CITY OF ALBUQUERQUE

Planning Department
David Campbell, Director

RE: **Lot 16 Block 2 Unit 2 S.A.D. 227**
6916 Rim Rock NW
Grading and Drainage Plan
Engineers Stamp Date 6/20/18 (D10D013)

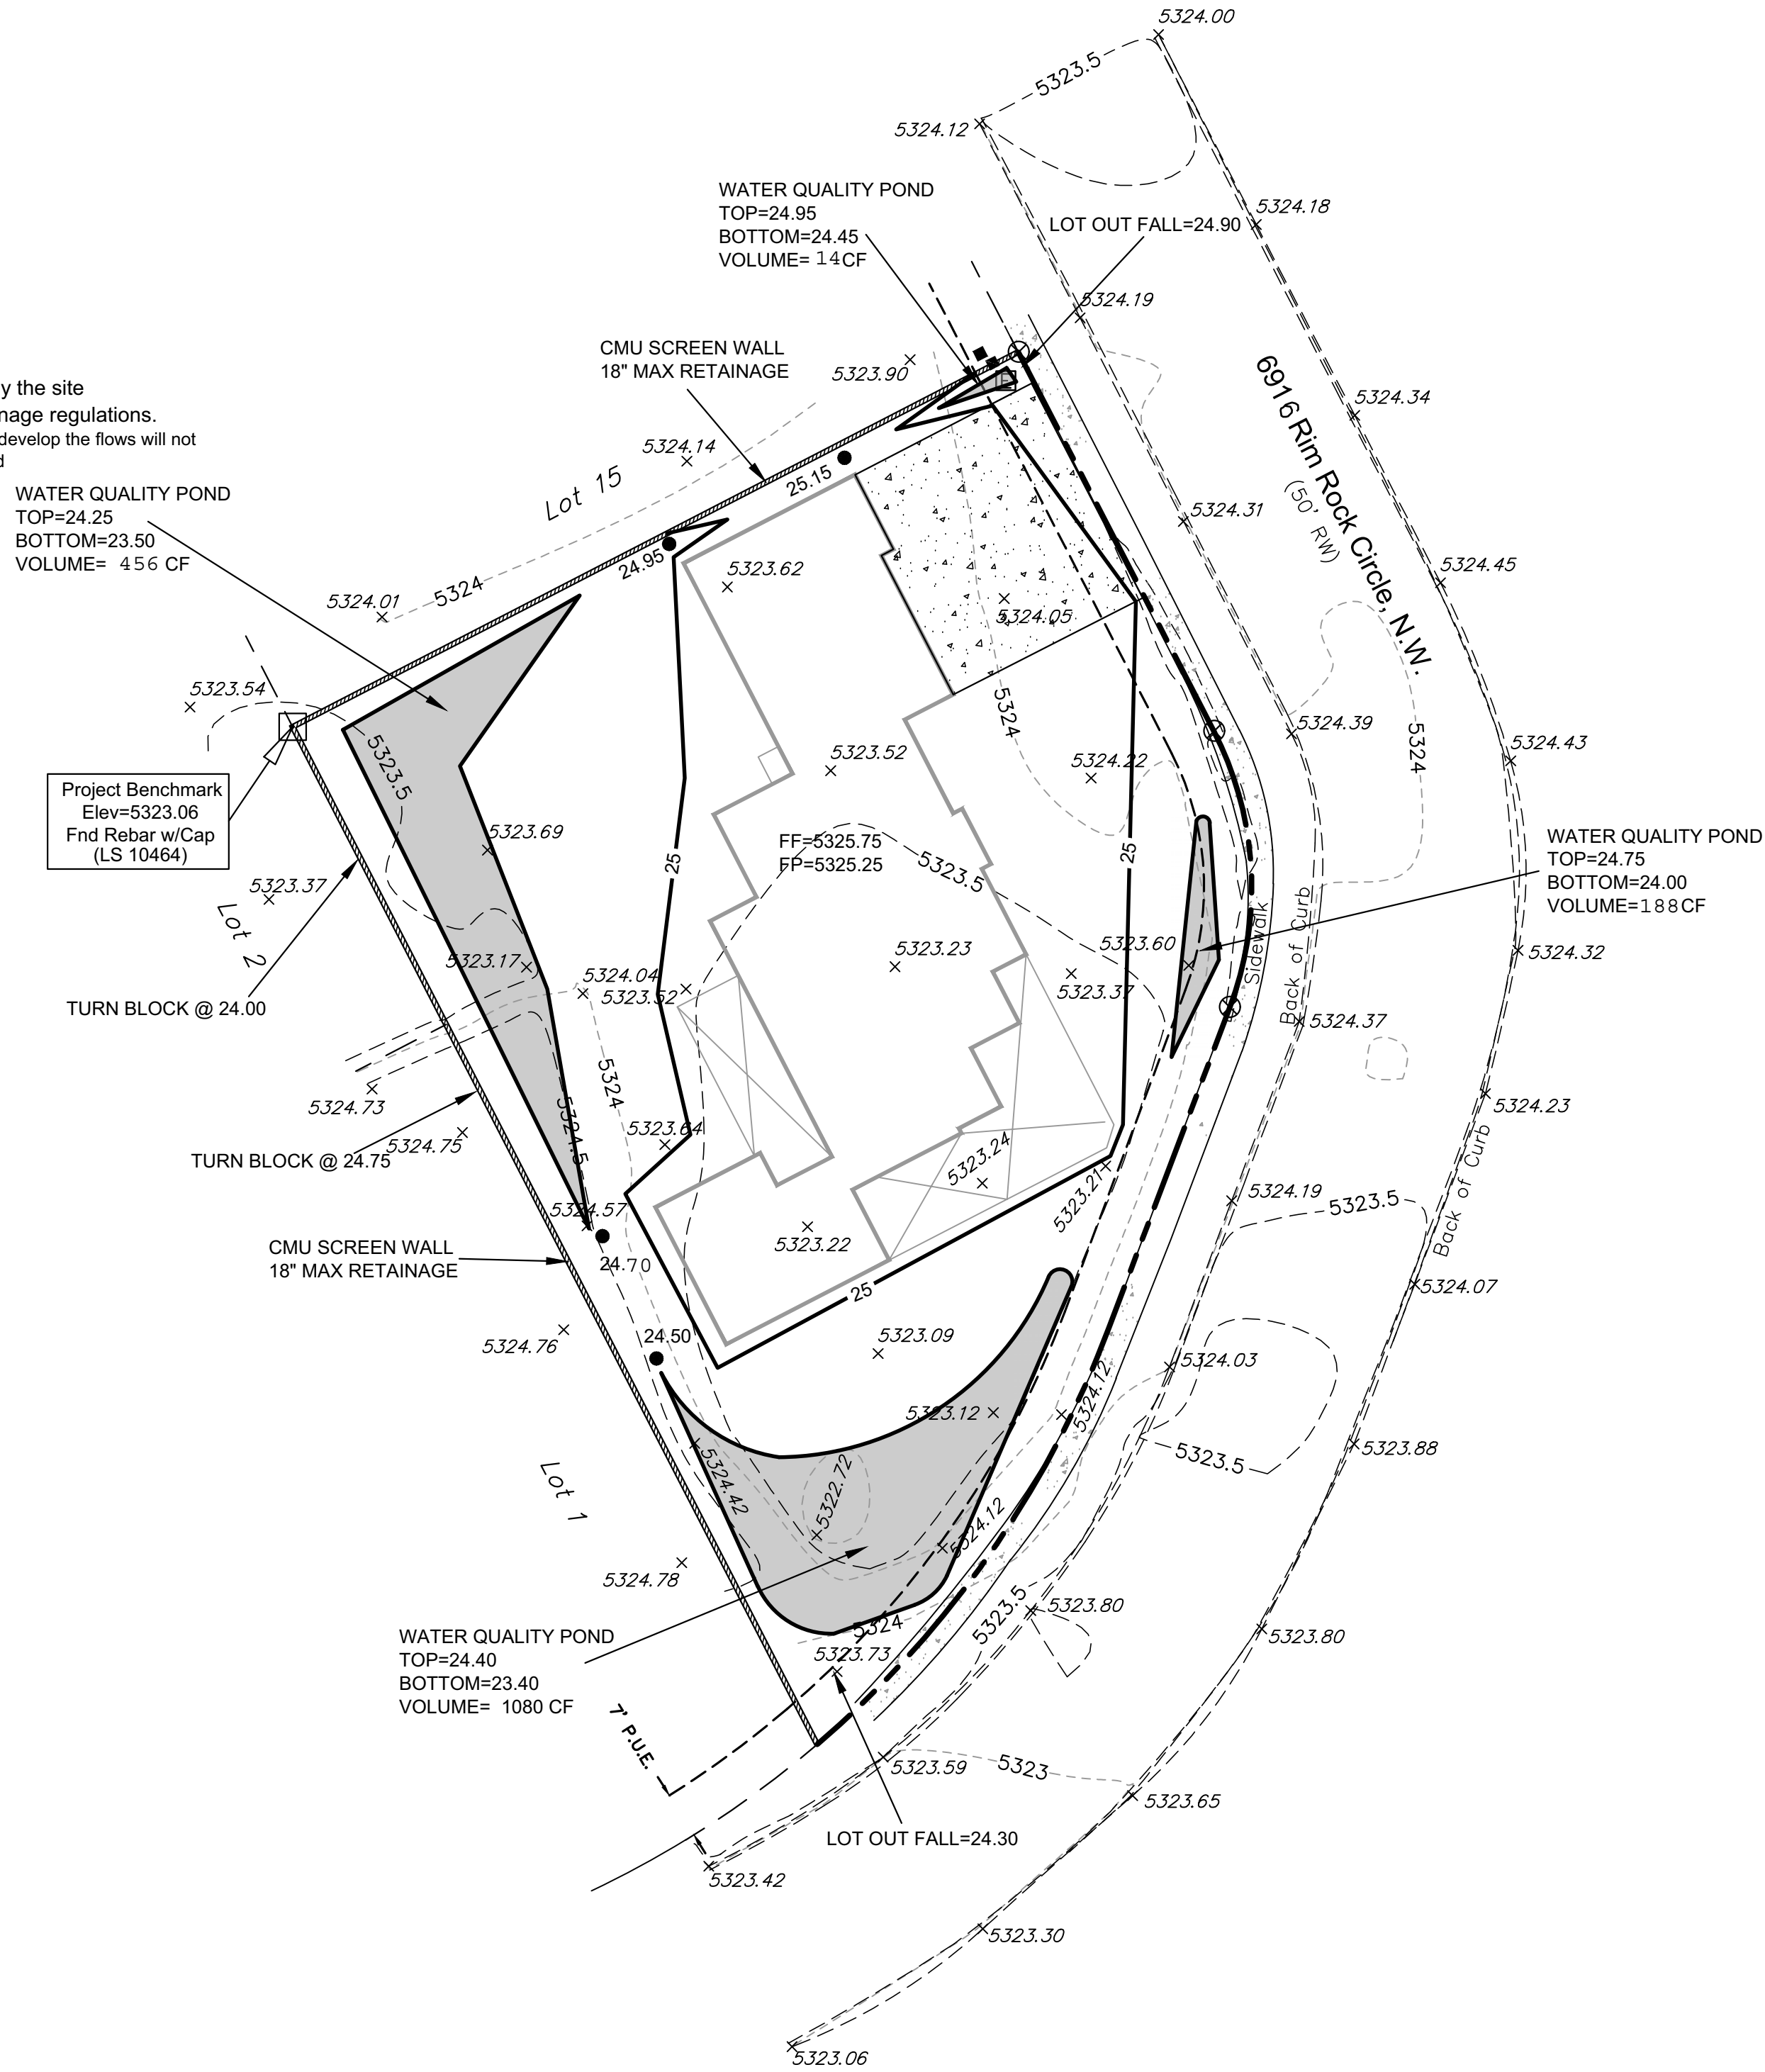
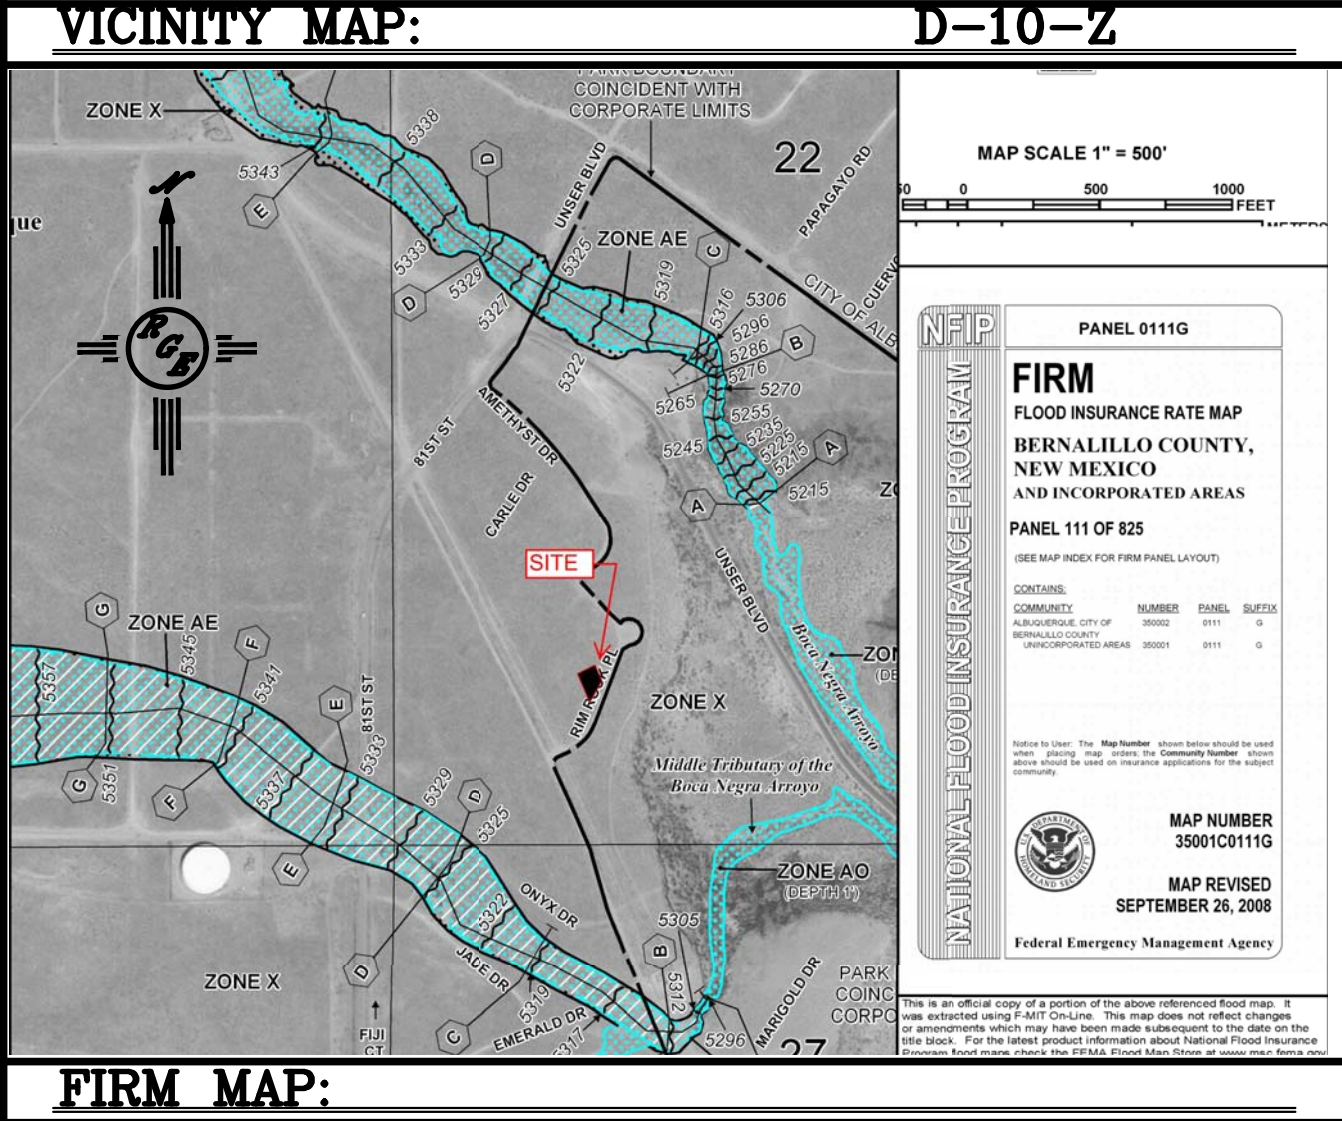
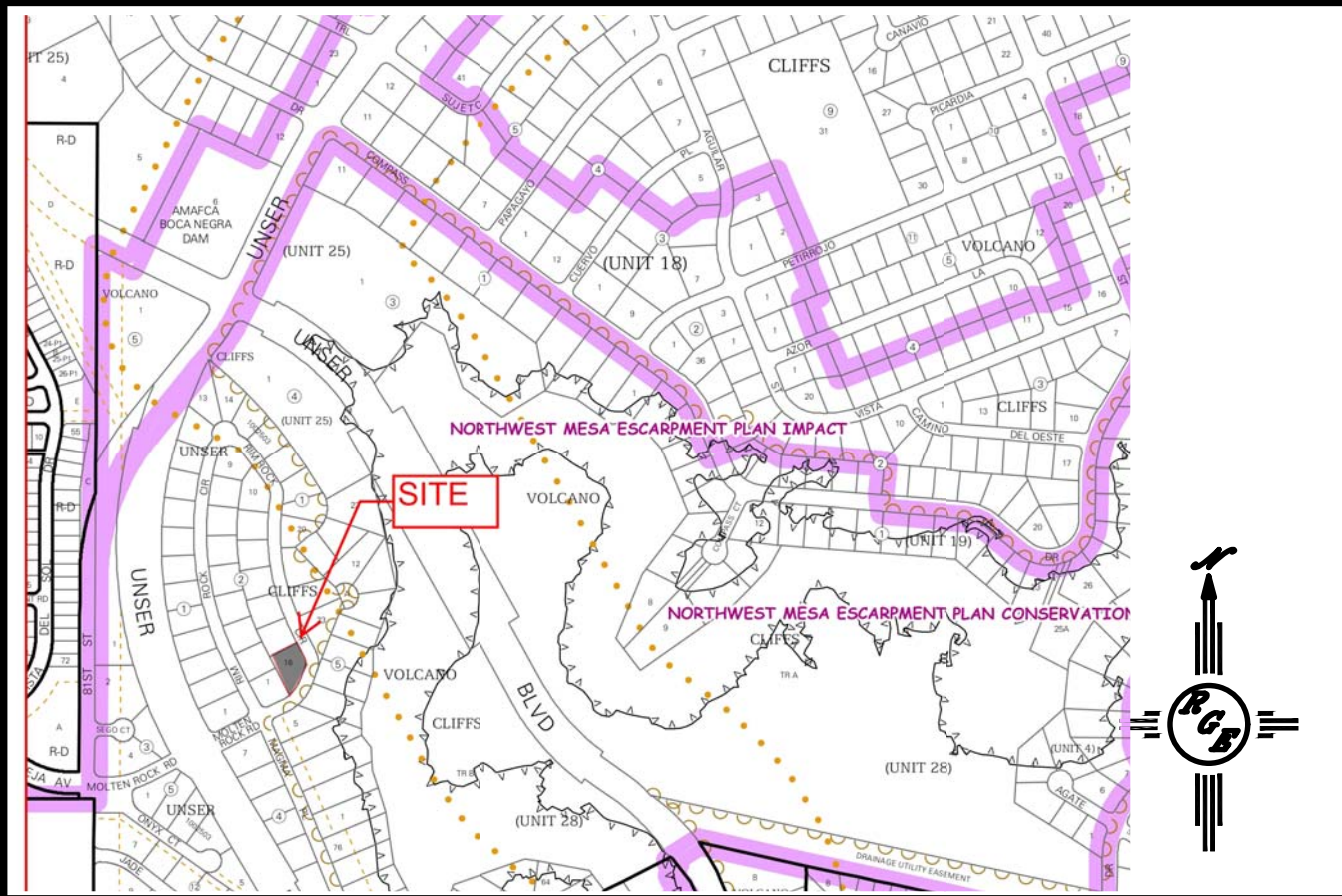
Based upon the information provided in your submittal received 6/21/18, this plan is approved for Grading Permit. Please inform the builder/owner to attach a copy of this approved plan and letter into the construction sets in the permitting process prior to sign-off by Hydrology.

Reiterate to the Owner/Contractor that a separate permit for a garden/retaining wall must be obtained, with the approved G&D plan.

Prior to Building Permit approval, a **Pad Certification** will be required.

Prior to **Certificate of Occupancy release**, Engineer Certification per the DPM checklist of this plan will be required.
